Our Ref: OSK7105-0006

Your Ref: ROL/2026/54

RE: INFORMATION REQUEST FOR 17 COURTNEY DRIVE, UPPER COOMERA QLD 4209 & 176 BAILEYS MOUNTAIN ROAD, UPPER COOMERA QLD 4209

We refer to the City of Gold Coast's Information Request (IR) issued on 2 July 2026 regarding the Development Application lodged by Courtney Upper Coomera Developments Pty Ltd C/- Saunders Havill. On behalf of our client, please find below our response to the civil engineering items:

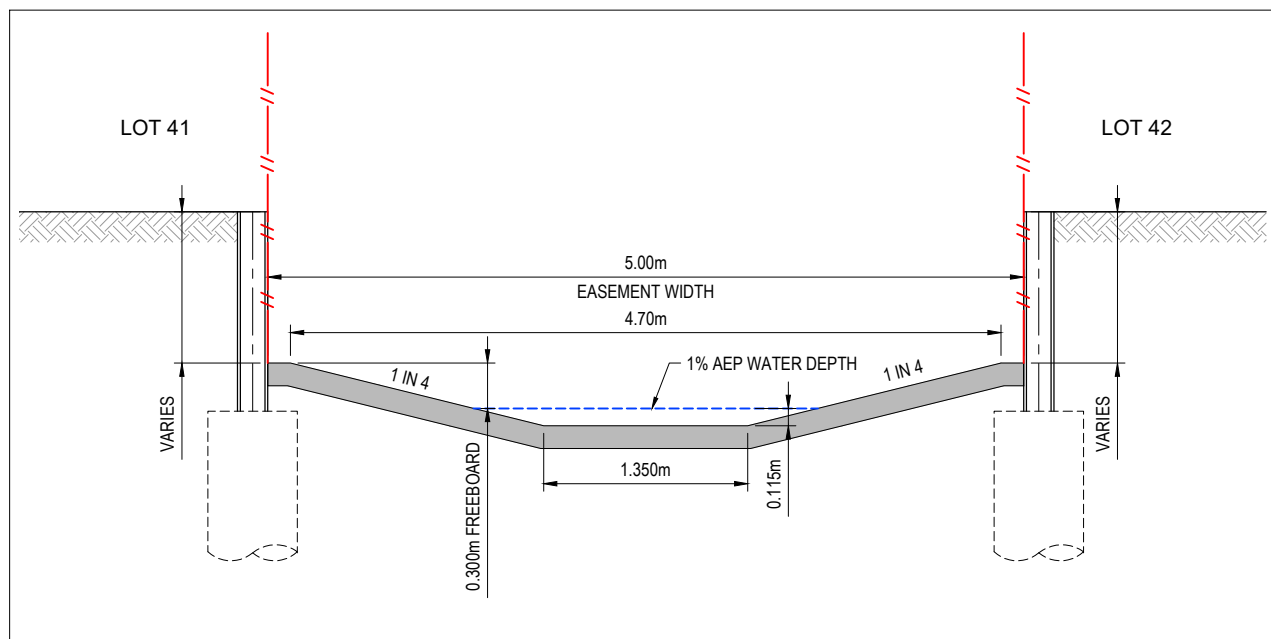
The applicant is advised that conditions consistent with those that were/will be imposed under ROL/2024/116 are proposed to be replicated for this application, requiring the realignment and upgrade of Courtney Drive.

In this regard, the applicant should consider whether the required realignment of Courtney Drive may affect the design, layout or positioning of the proposed intersection to Courtney Drive, and whether any amendments to the current design are necessary to maintain appropriate access and intersection functionality.

RESPONSE: Refer response to Item 12.

TITLE	DRAWING NUMBER	REVISION
TEMPORARY BASIN ACCESS SKETCH PLAN	OSK7105-SK004	0

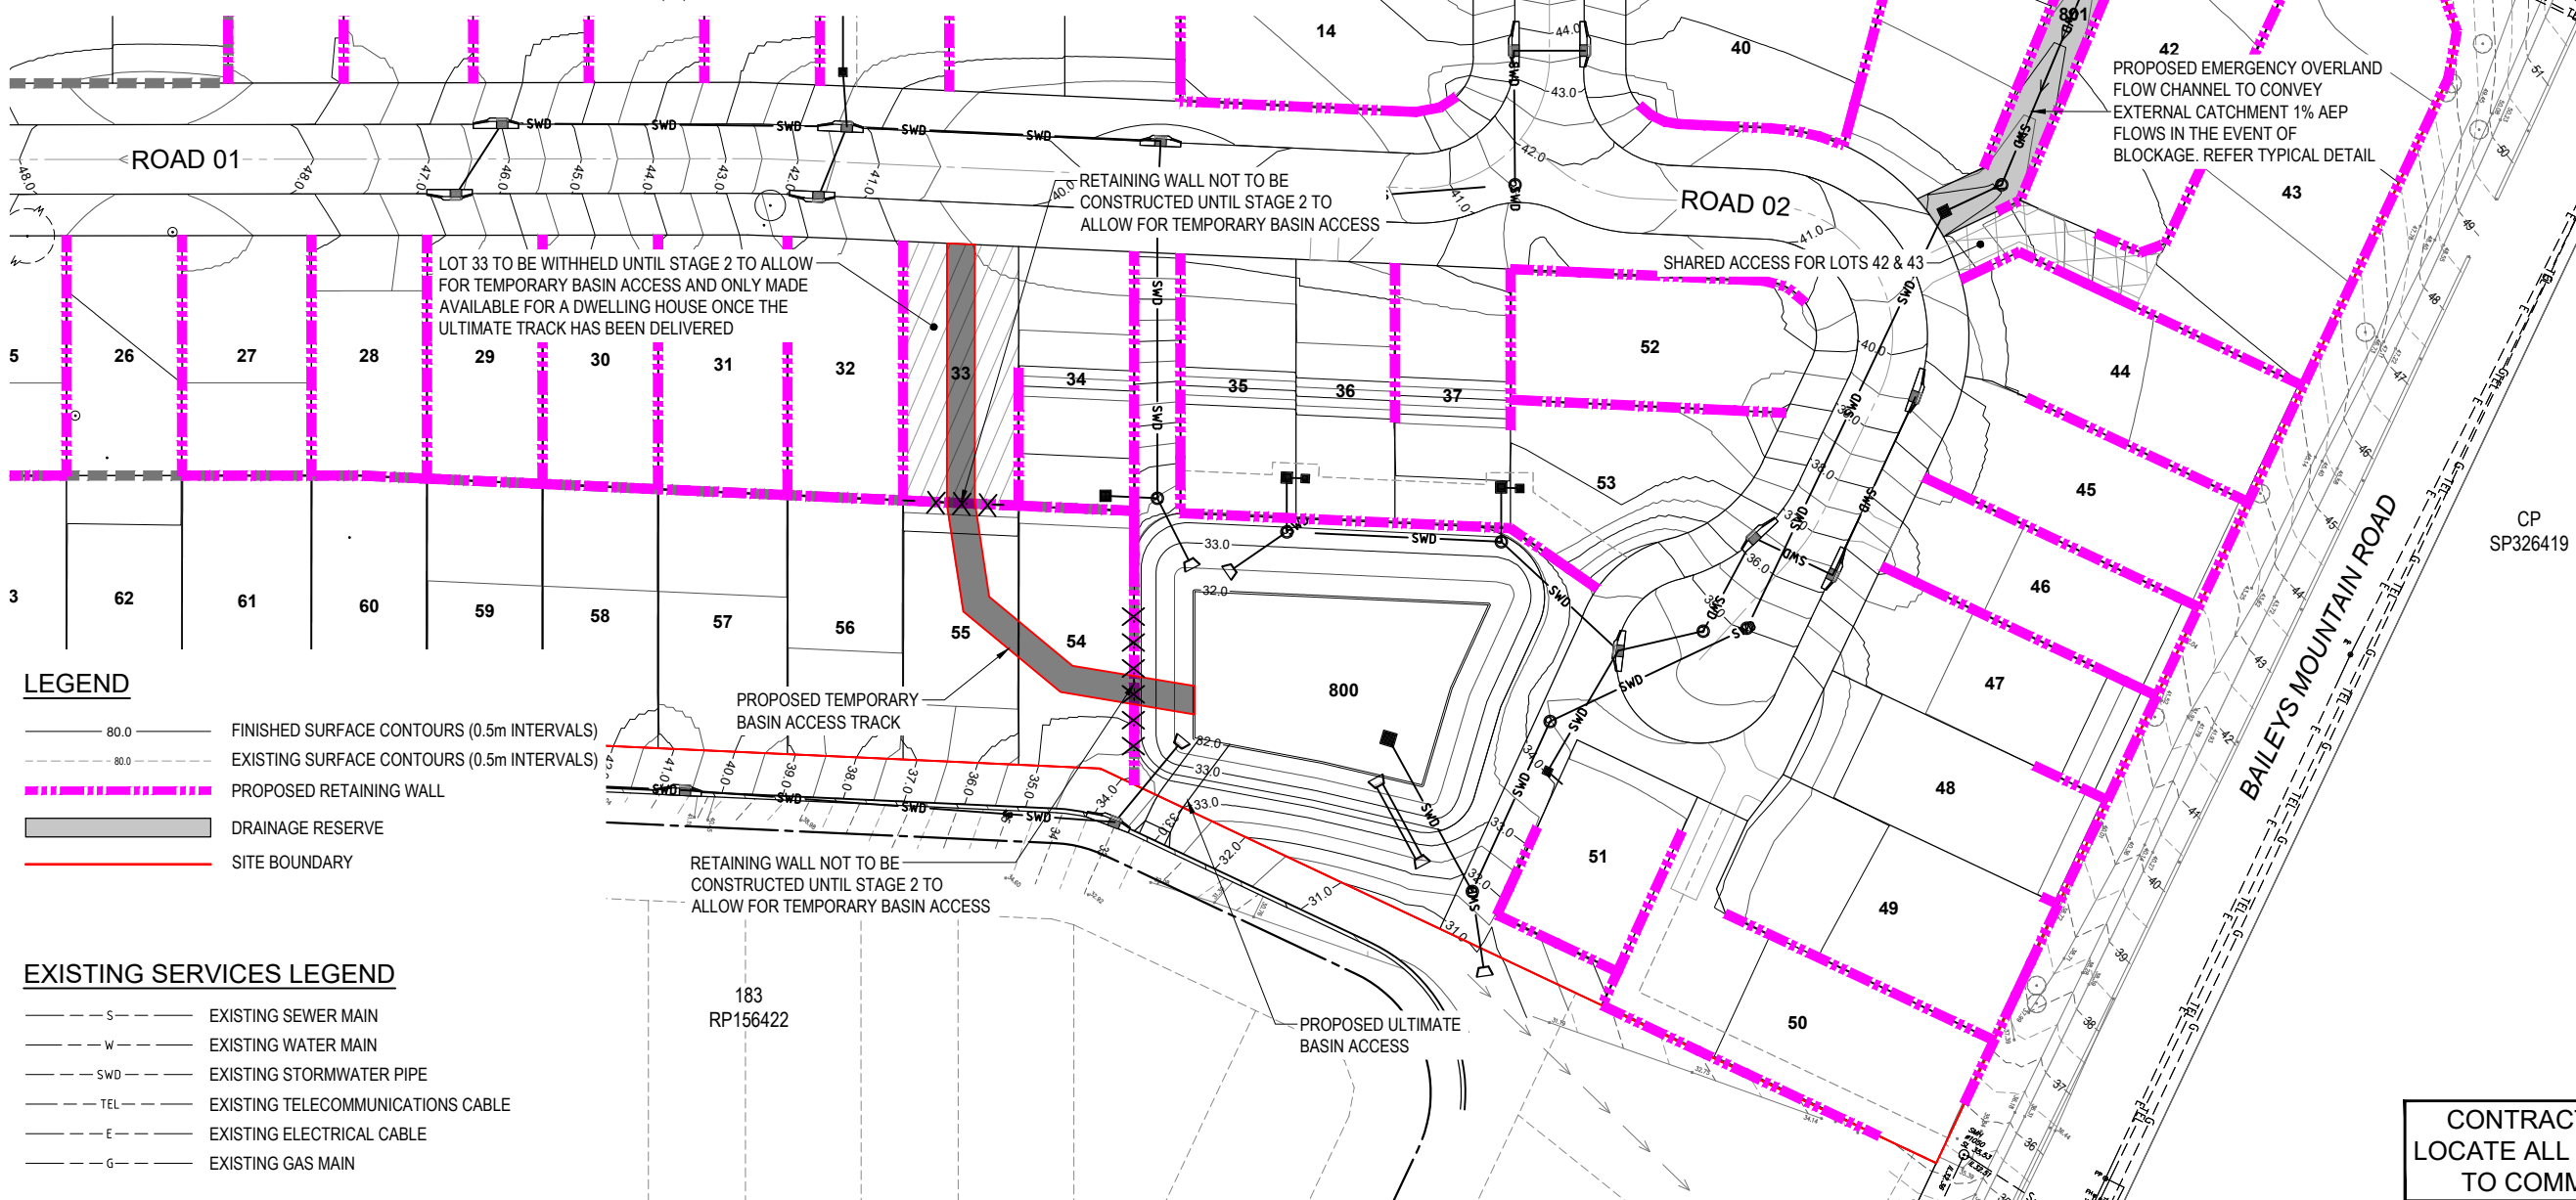
The proposed development defers Stage 2 (comprising of proposed lots 54 to 63) until such time as the proposed Road 02 within Stages 1 and 2 of separate ROL/2024/116 is delivered. City officer review of the proposed Statement of Landscape Intent (SLI), Preliminary Services Plan, and Preliminary Bulk Earthworks Plan are showing a vehicle crossing from the proposed detention basin in proposed lot 800 to the proposed Road 02. However, the detention basin is to form part of Stage 1a (which is not reliant on proposed Road 02).

The applicant is requested to provide an alternative outcome that ensures all components required to undertake Stage 1a can be wholly completed based on the infrastructure available to proposed Stage 1a.

It is proposed to withhold Lot 33 to allow for temporary basin access through the balance lot and Lot 33 to the basin if required. Refer to the Temporary Basin Access Sketch Plan included as an attachment to this response and the updated Stormwater Management Plan for further information. Note this temporary access will only be required if proposed Road 02 is not constructed before Stage 1A.
